Date: 10/12/2020
RFB No: **2020-054**
Commodity: **WMARSS Central Plant North Blower MCC (Motor Control Center)
Replacement Project**
Purchasing Agent: **Mr. Tim Cubos**

Addendum No: 3

**CITY OF WACO
OFFICIAL BID SHEET
BID INVITATION NO: RFB 2020-054
WMARSS Central Plant North Blower MCC (Motor Control Center)
Replacement Project**

Questions and Answers from the pre-bid meeting and thereafter:

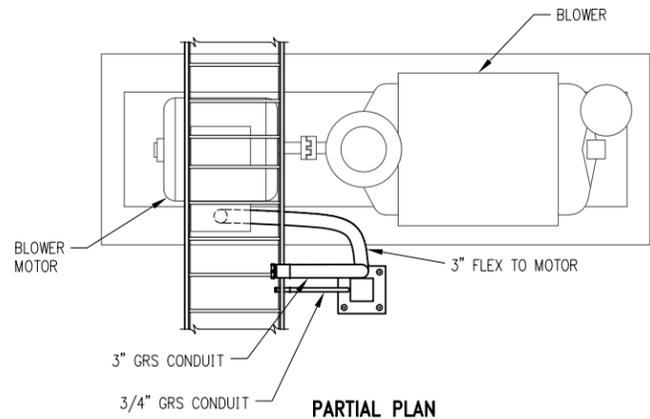
10. Could you please tell me what level of hardware you are wanting on the doors?
Grade 1?

Yes, Grade1, 316 Stainless Steel Hardware

301 CONDUIT SUPPORT TO MOTOR

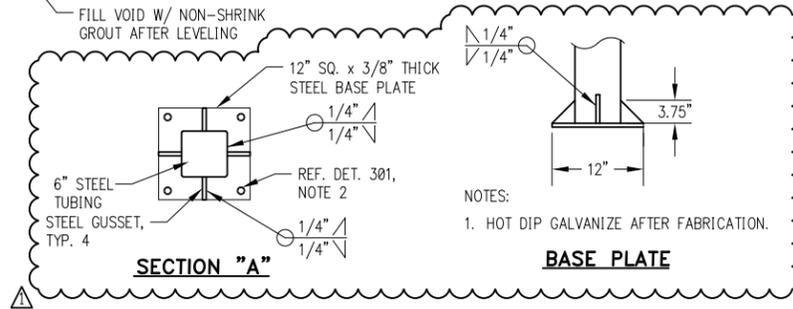
8. Detail 301 for the conduit support to the motors, shown on sheet E-16, appears to show the 3" rigid conduit inside the 6" square tubing, is this correct or is it located on the outside of the square tubing? What material is the conduit support to be made out of? Aluminum or steel?

The 3" conduit is on the outside of the 6" square tube support. Reference attached revised sheet E-16.

- NOTES:
- 6" NON-TAPERED SQUARE STEEL TUBING SUPPORT, 7 GA. WALL THICKNESS. HEIGHT AS REQUIRED. TUBING SUPPORT SHALL BE HOT-DIPPED GALVANIZED AFTER FABRICATION.
 - HILTI HIT-RE 500 V3 SAFE SET SYSTEM WITH 5/16" HILTI HAS THREADED ROD. MINIMUM 6" EMBEDMENT. TYPICAL 4 PLACES EACH SUPPORT STAND.
 - SUPPORT STAND SHOWN FOR BLOWER No.1 AND IS TYPICAL FOR 5 BLOWERS
 - GROUND TUBING SUPPORT WITH POLE GROUND LUG AND #2 TPC CADWELD TO CABLE TRAY.
